City of Rochester

PLANNING COMMISSON REGULAR MEETING AGENDA

400 Sixth Street	December 1, 2025	7:00 PM
-------------------------	-------------------------	----------------

Subject: Brillati Family Office/134 S. Main Development Project; Preliminary Plan Review #2; Revised site plan set dated 11/7/2025.

4 SOUTH ELEVATION
SCALE: 3/16" = 1'-0"

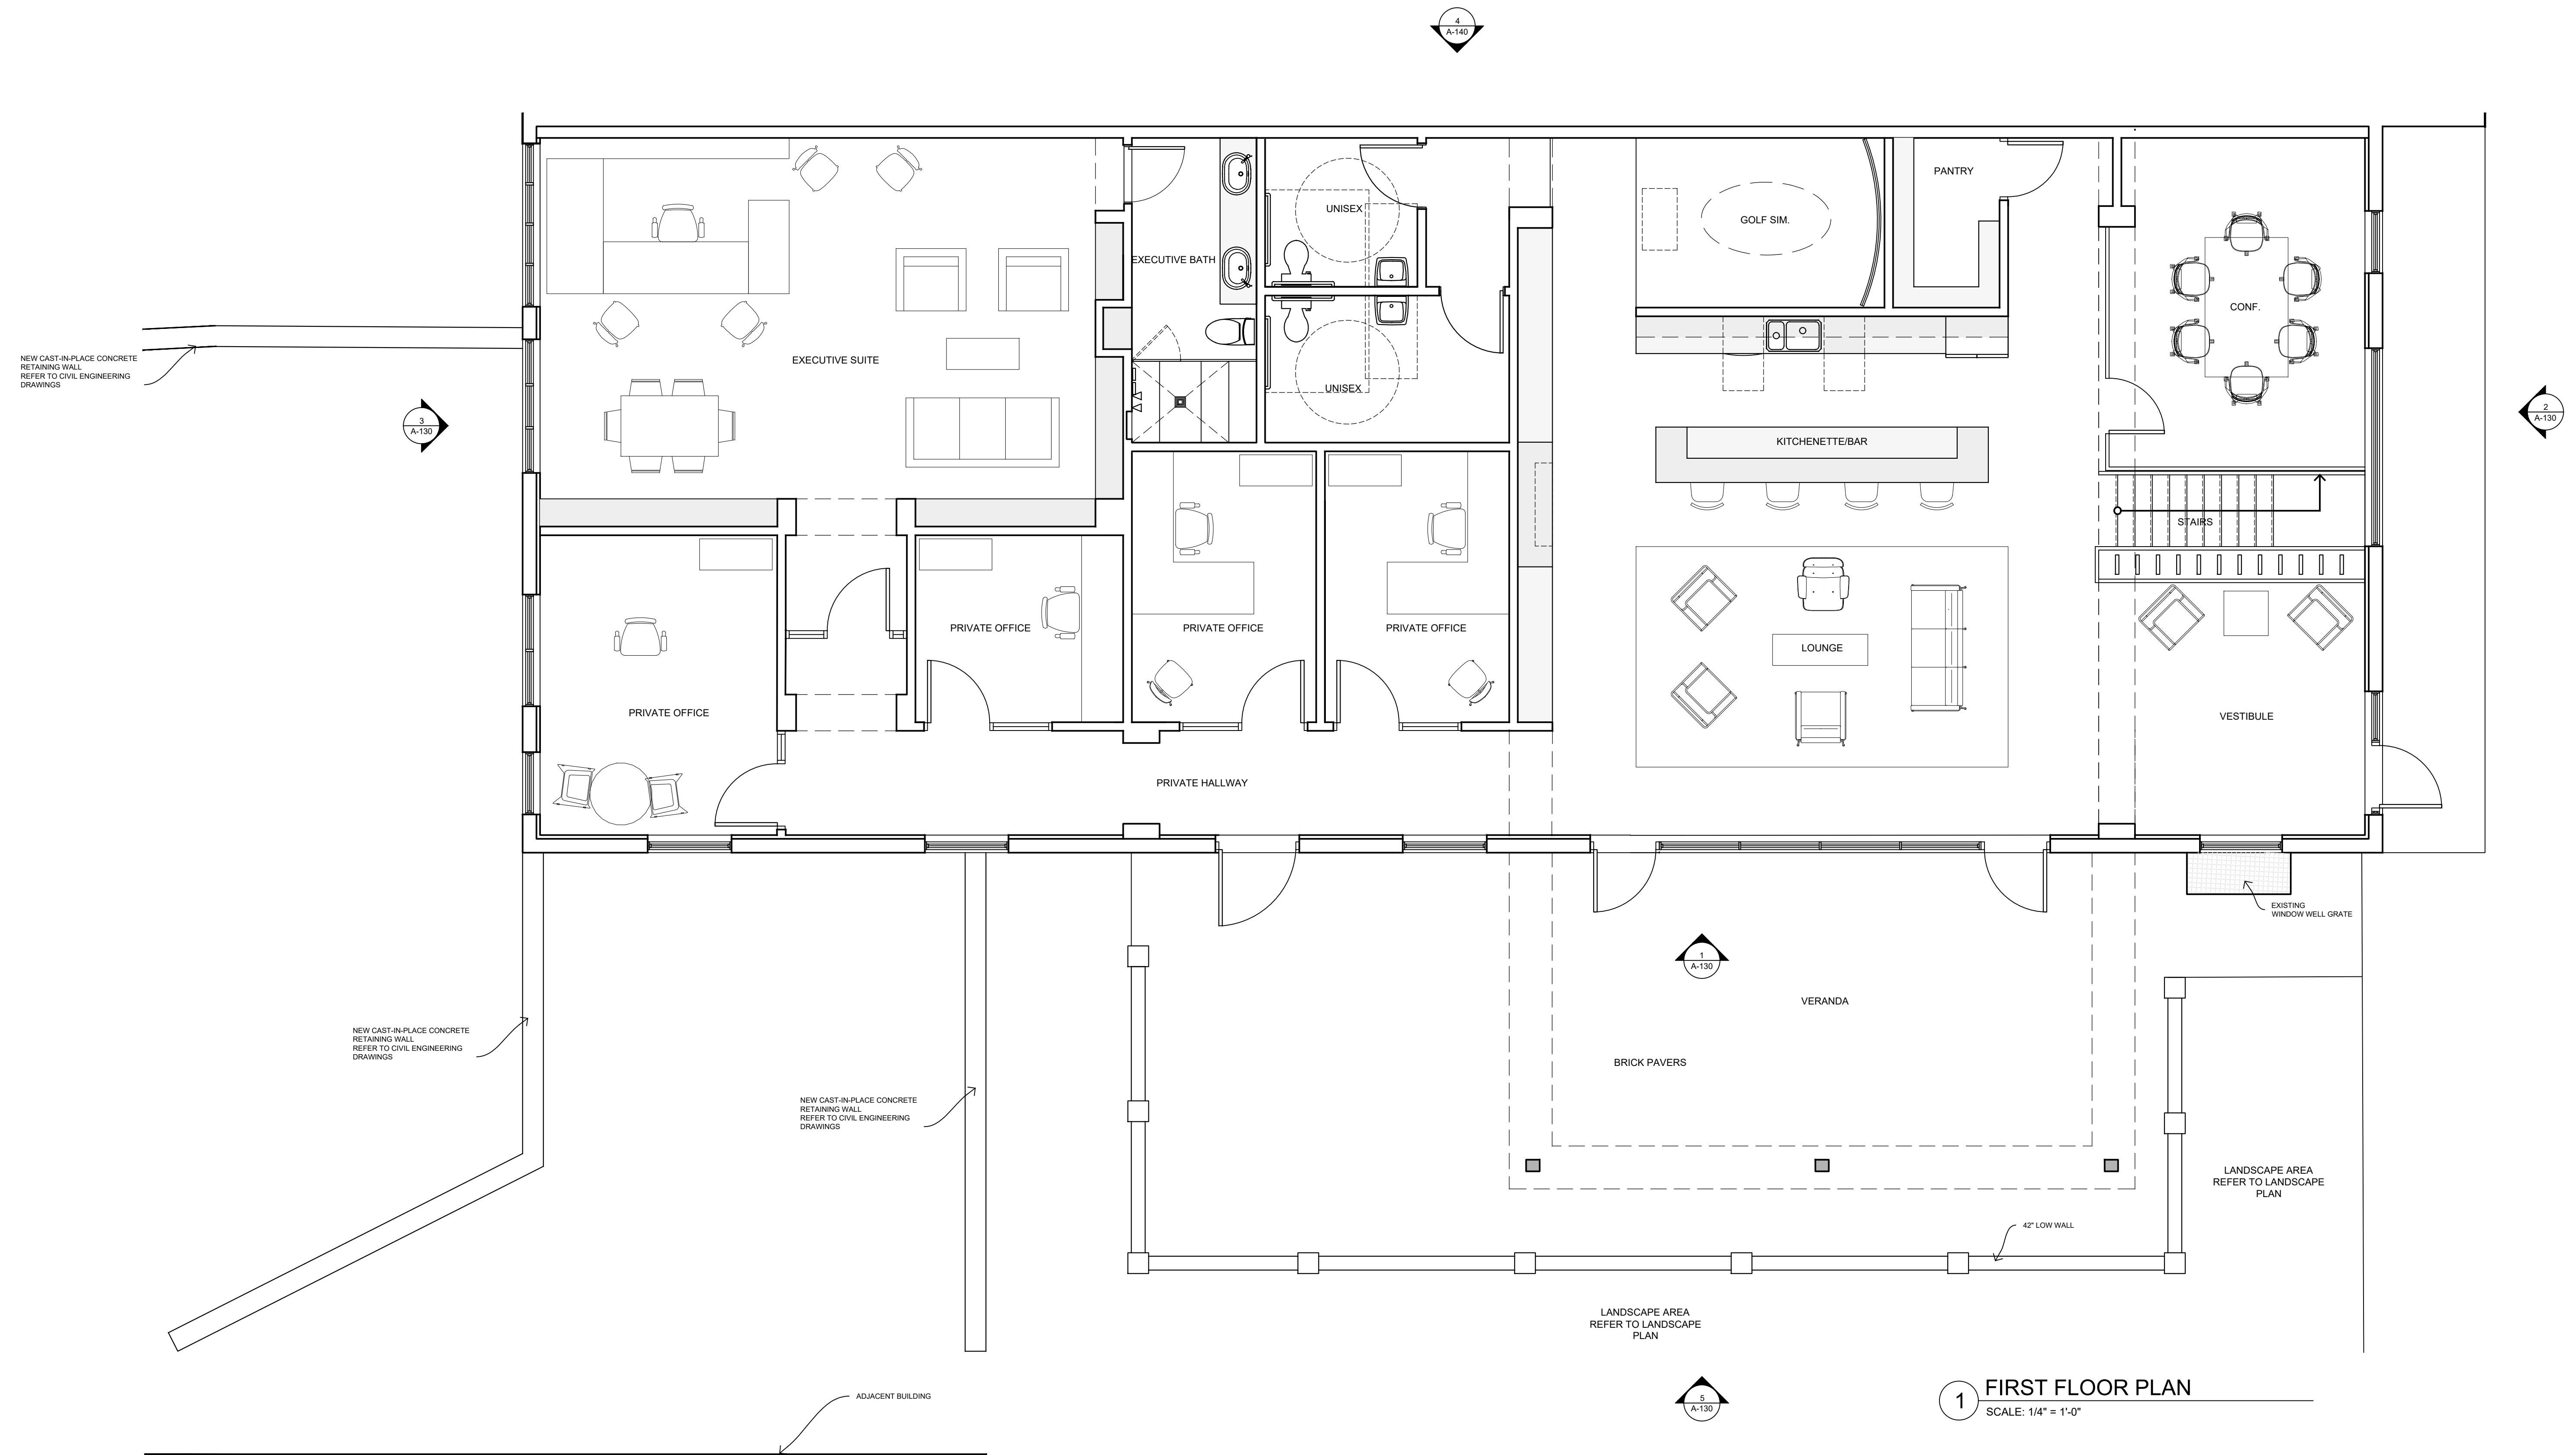
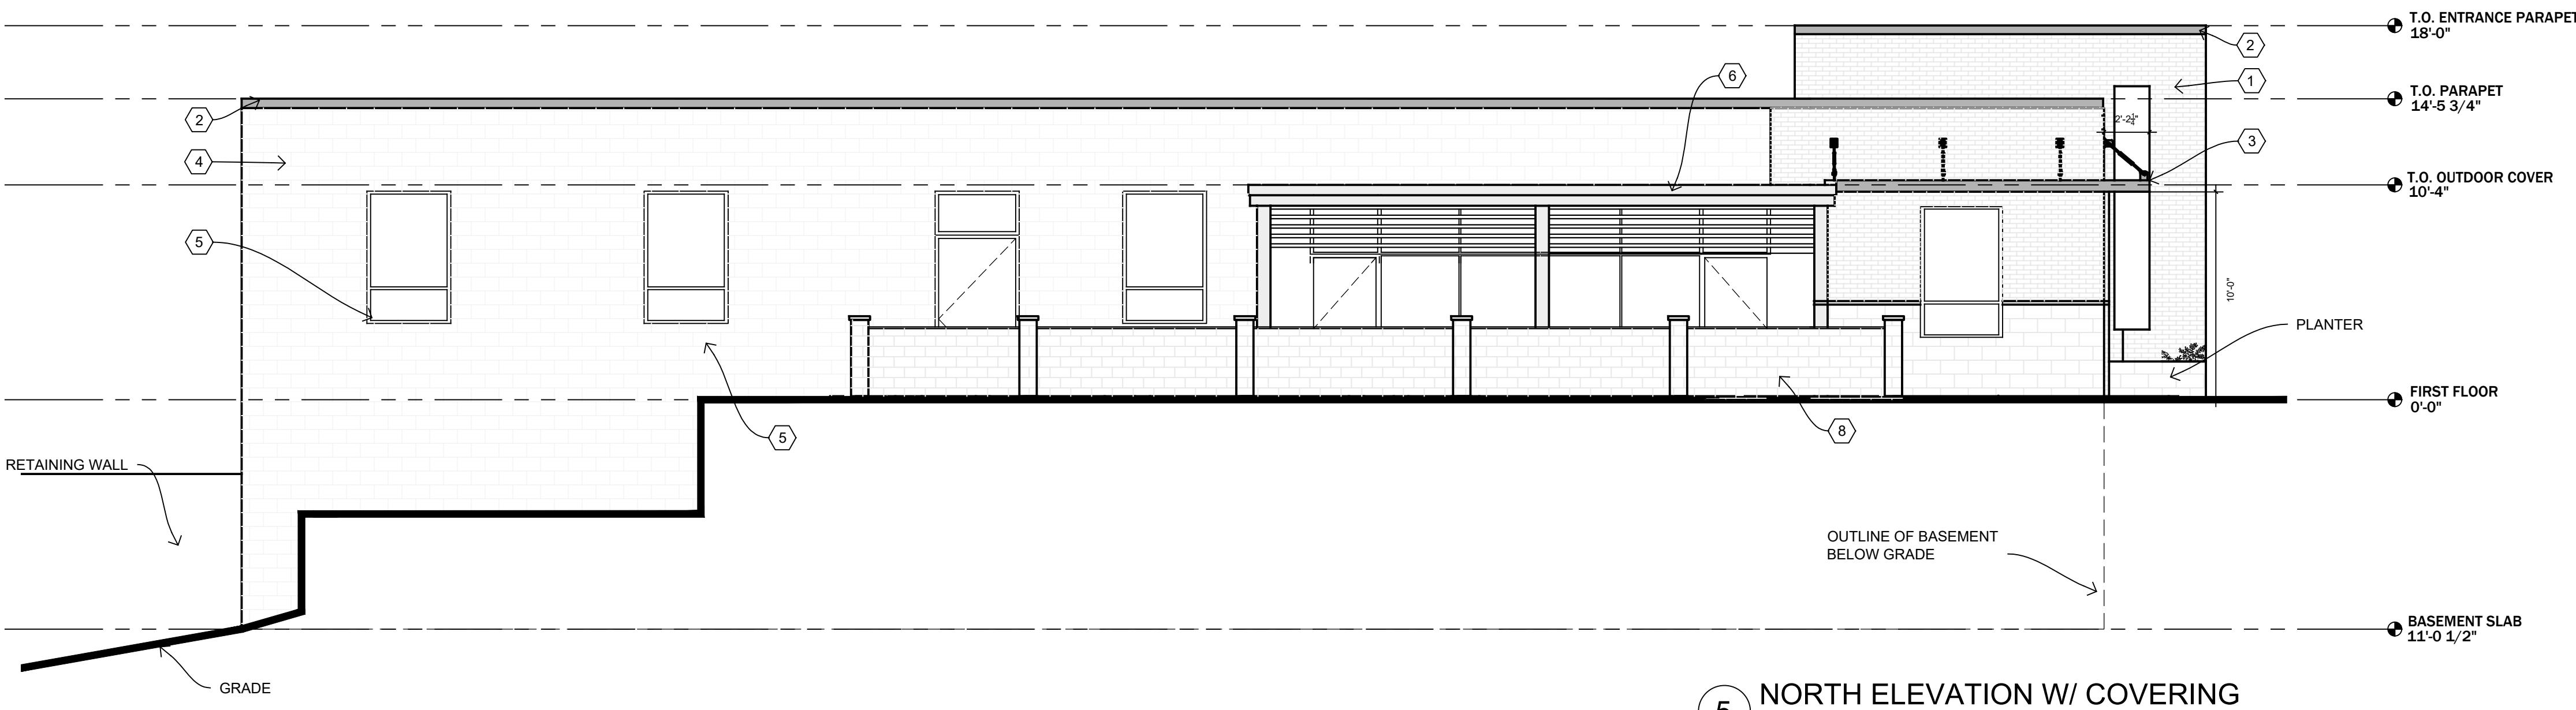
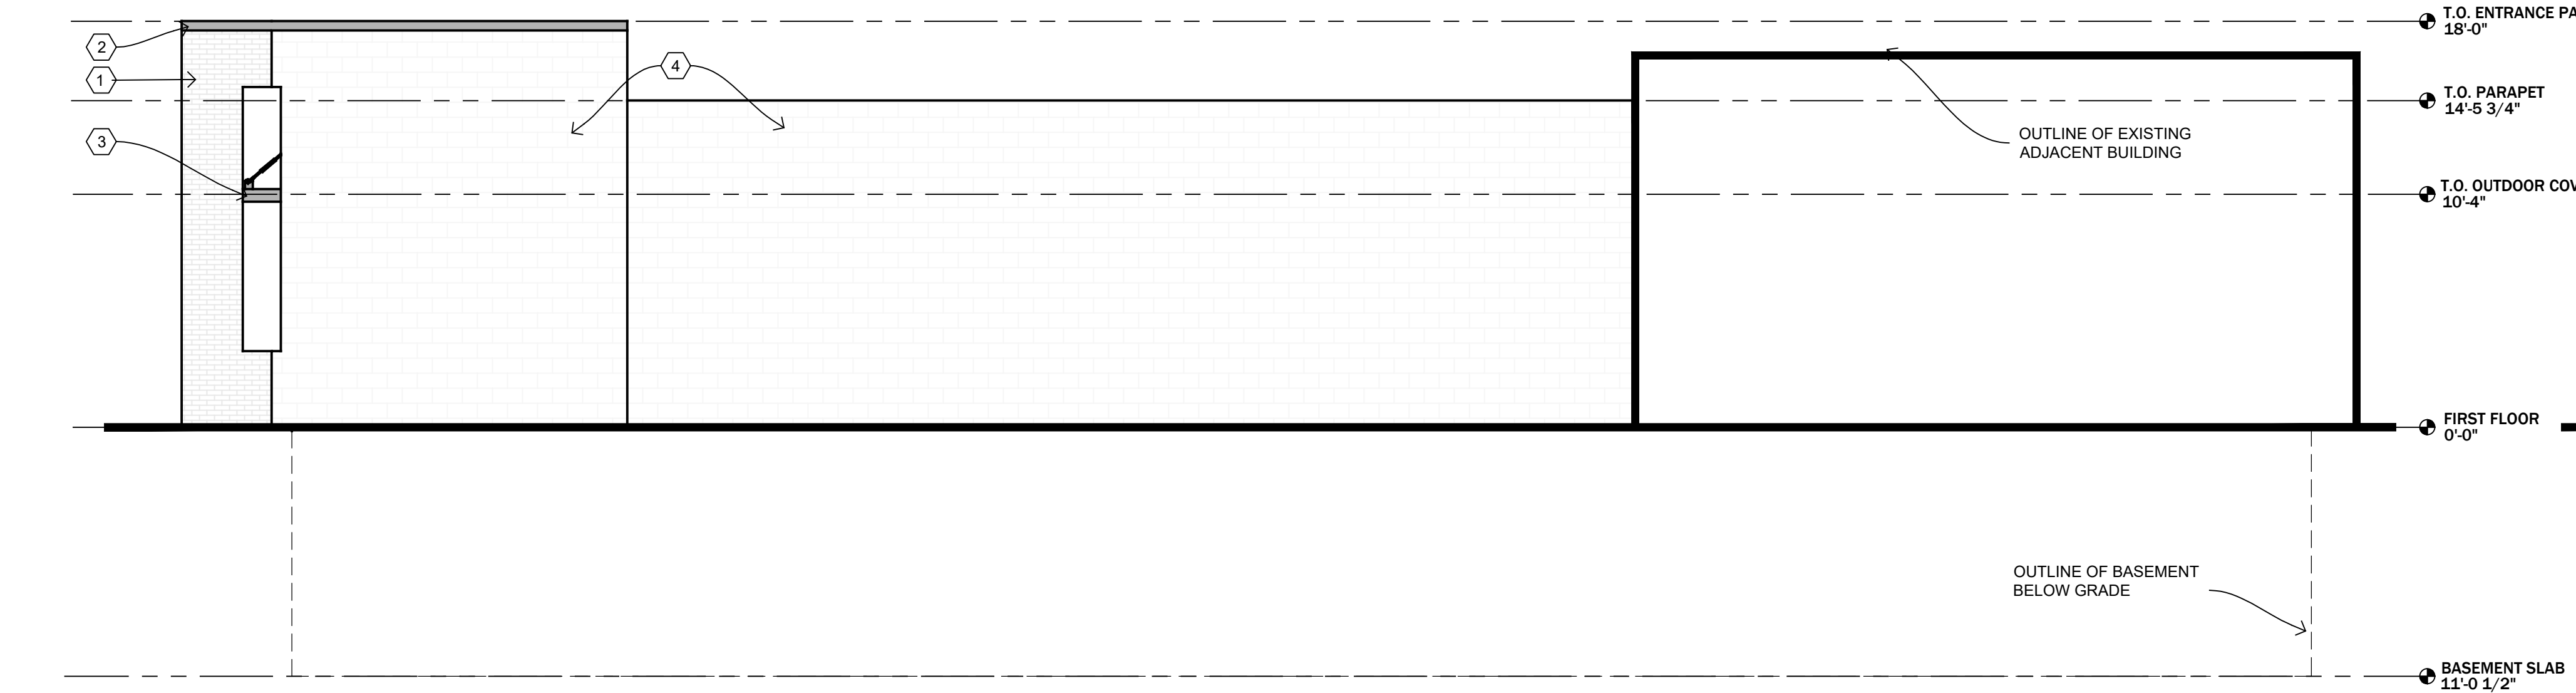
9. The existing building is constructed of CMU blocks and is in a state of disrepair. The applicant proposes to retain the block and add a façade of cast limestone and brick to the west (front) and north facades. The colors are beige/earth tones with black trim and accents. The proposed architecture creates an attractive west and north façade; however, the south façade is a large blank masonry wall and is visible upon entering the Downtown.

We had previously recommended that the applicant consider adding a band of the primary building material across the south façade or add faux windows with spandrel glass or other designs to provide visual relief to this façade and demonstrate compliance with Section 2118 (1) of the Zoning ordinance.

The applicant has responded that the south facade will only be repaired and painted. Addition of some brick or limestone detailing on the south façade will greatly enhance its appearance on par with the proposed upgrade on the north and west sides. Planning Commission input is sought.
